SERVICE BULLETIN

DATE: December 20, 2017 Service Bulletin No. 633
Engineering Aspects are
FAA Approved

SUBJECT: Oil Level Gage (Dipstick) Replacement

MODELS AFFECTED: Lycoming Engines TIO-540-AH1A installed in Gipps Aero/Mahindra Turbocharged GA8 Airvans

Figure 1
Replacement Oil Level Gage P/N 56C23673P

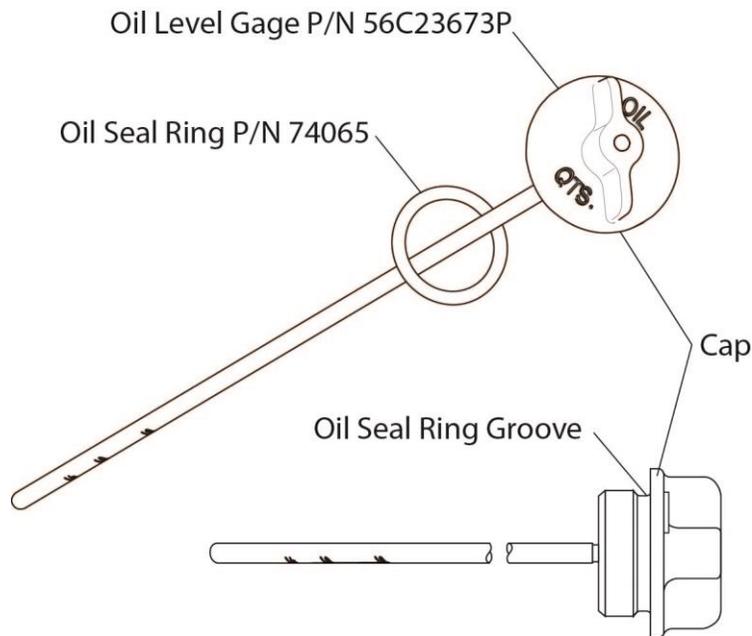
- B. Install the new oil seal ring P/N 74065 on the new replacement oil level gage P/N 56C23673P; make sure the oil seal ring is correctly seated in the groove under the cap. Refer to Figure 1.
